Deerfoot Trail Study

Deerfoot Trail Phase 3: What we Heard

February 12, 2020

ACCESS OPTION # 1: EAST-FACING RAMPS ONLY

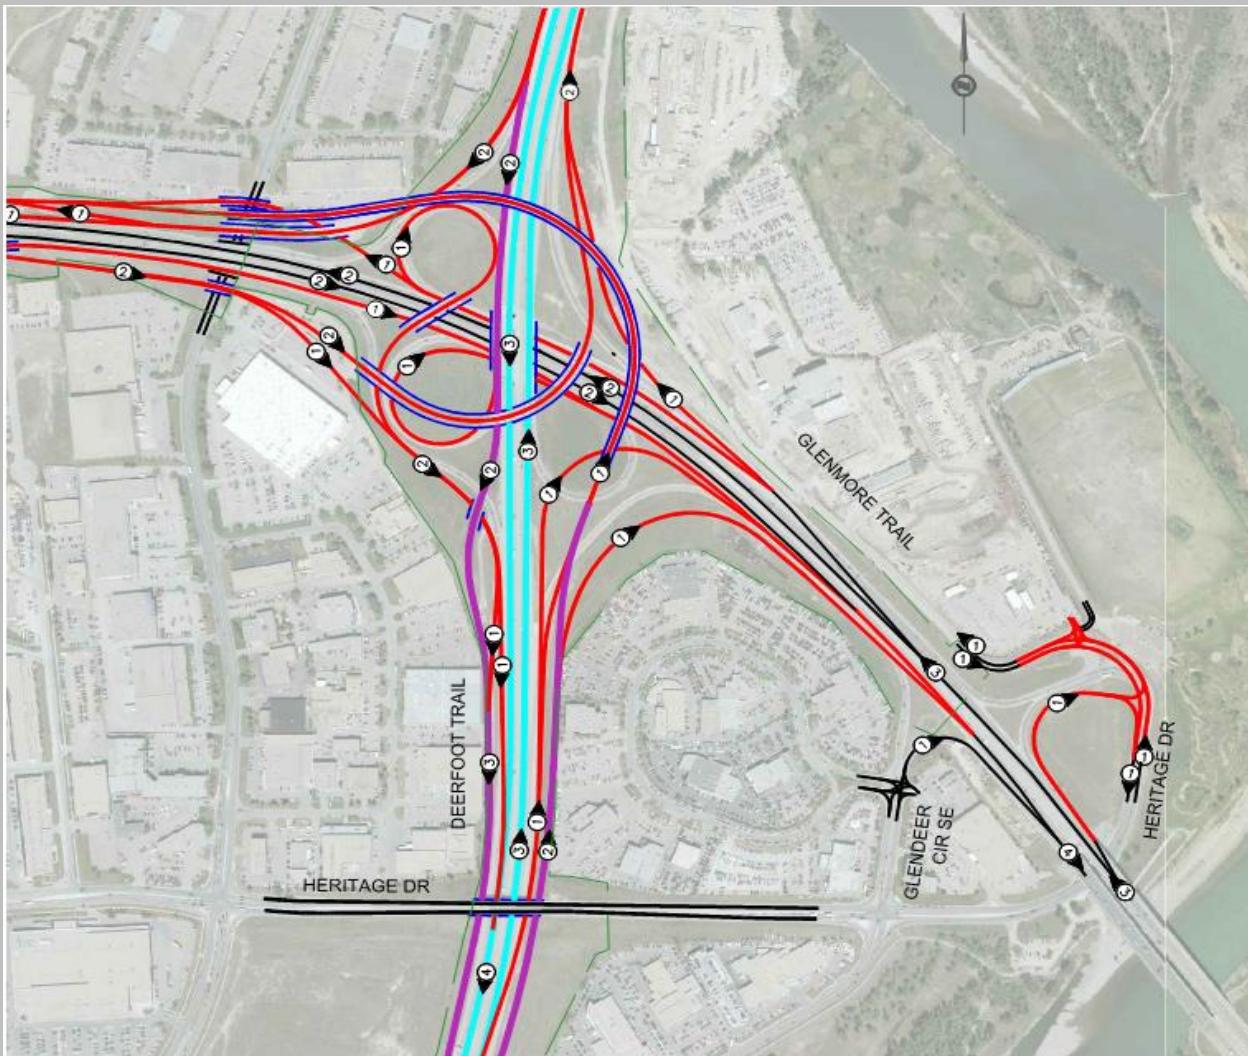
Participants indicated that this option would have a strongly negative to strongly positive impact to the interchange area when weighing in the factor of safety.

ACCESS OPTION #2: FULL ACCESS

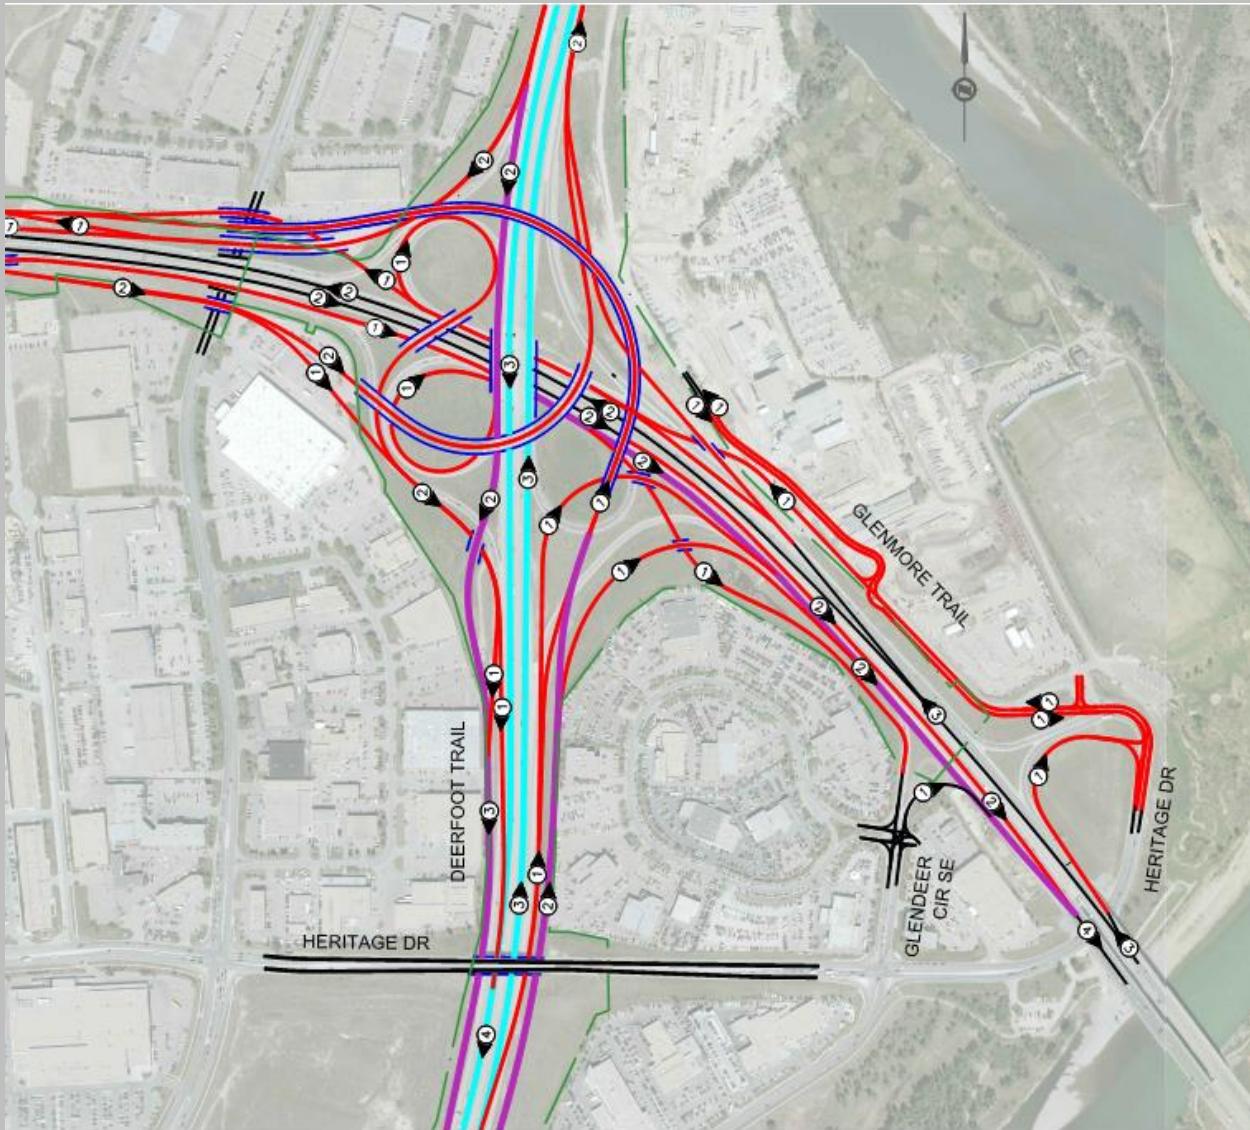
Participants indicated that this option would have a negative to neutral impact overall to the interchange area, with the exception of safety, which participants indicated was strongly positive.

Anderson / Bow Bottom / Southland — Three Preliminary Concepts

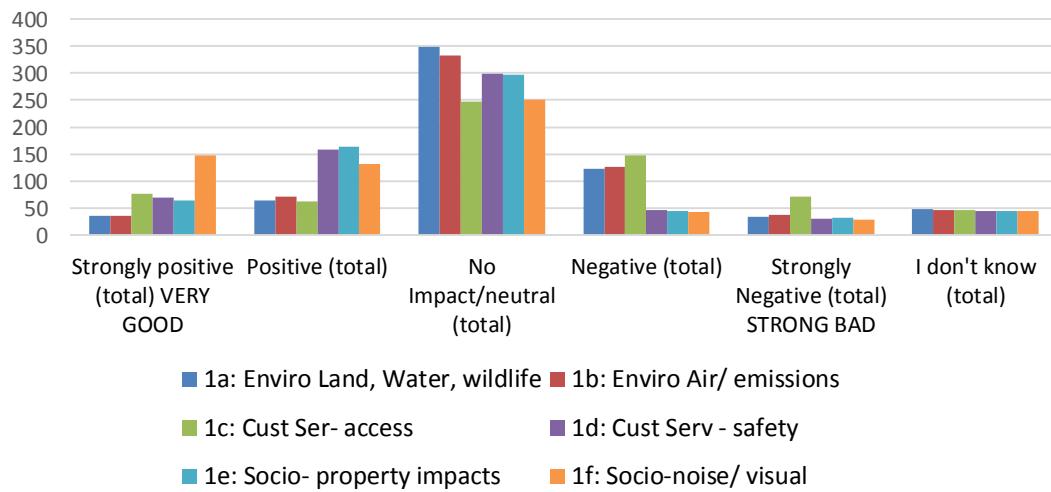
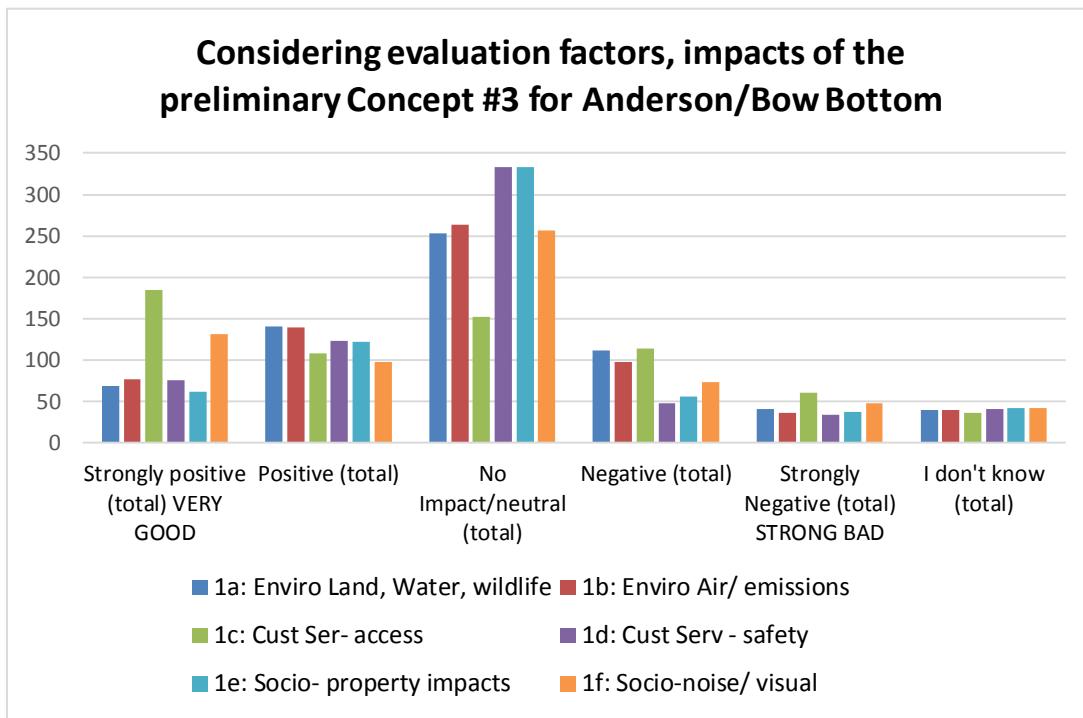
Top Themes That We Heard	Participant Verbatim Comments
<p>Overall General Agreement <i>(About concepts for Anderson/ Bow Bottom)</i></p>	<ul style="list-style-type: none">• With Anderson become more important with Stoney Trail, this will see increase traffic East/West. Let's do it right.• When ever I'm driving on that bridge over the river there is always traffic, I feel like anyone of these would help my daily commute• I think all three plans have minimal social and environmental impacts. Taking advantage of the vacated Lafarge property before any future development takes place is critical. Once built up, there will be fewer options and more opposition. #3 addresses the weaving traffic the most effectively• Lots of great ideas/options. I am most interested in ANY option that provides immediate relief for the current congestion. A basket handle option for Deerfoot South where it crosses over before Bow Bottom exit seems like a "quick win" and relatively low cost (so Option #1) that could still work for the longer term/more expensive options.• Any of these projects will have some impact on adjacent properties. There is a strong need for improved traffic flow for safety reasons• Positive outcomes are inevitable for any of the 3 concepts. Any improvement is better than what we have now!• This is the most important change out of all proposed changes, this needs to happen first• Solution 3 does something the others don't - and that is creating a direct on-ramp from Blackfoot to Deerfoot. Really REALLY needed.• Northbound between 24St and Anderson is DANGEROUS in the afternoons. The increased capacity and separate exit lanes would be greatly appreciated.• All concepts present some good solutions. The most ideal concept would be Concept 2 if it had the basketweave ramp for SB Deerfoot but instead it keeps a weave zone making it the worst choice.

<ul style="list-style-type: none">• Other than Deerfoot & Glenmore this is the most important interchange to address. The appropriate amount of funds need to be spent making these adjustments correct and future proof. No cost cutting
<p>Suggestion to the Anderson / Bow Bottom Concepts <i>(To specific concepts 1-3 or overall interchange area)</i></p>	<ul style="list-style-type: none">• I agree with increased lanes across the bow river to Southland. I think what is missing is a solution to the issue of bottlenecks approaching Anderson NB with cars merging onto Deerfoot at 24th street• One thing that also needs to be considered here is the traffic merging off Douglasdale. Quarry Park continues to expand leaving to a ton of traffic darting out from a not-moving Anderson line up.• An expedited connection between Deerfoot and Blackfoot is unnecessary• Any crossing merges between blackfoot to deerfoot south, deerfoot south to anderson or bow bottom should be completely removed to make this worthwhile. Concept 3 looks best. Define Lanes better

Benefits specific to these concepts *(Concept-specific benefits and high-level comments for all the preliminary concepts)*

- Option 3 is the only option that fixes flow in both directions
- Prefer concept 3 because direct access to Southland/Blackfoot/shopping reduces much weaving. I hope signage is also improved on all concepts for all interchanges.

- 3 is best because it adds blackfoot access to deerfoot w/o Southland AND Ebound Southland to S Deerfoot access.
- If you're truly trying to fix the problems then go with the most robust plan (option 3 IMO). Add cycling options, continue to fund greenline & other transit to mitigate continued car commuter growth

- Option 3 is the only one that will truly positively impact this area.
- concept 1 & 2 look to provide little to no changes. Concept 3 looks to reduce lane switching and improve flow. The golf course probably should be considered to be closed anyways. No concern losing it.
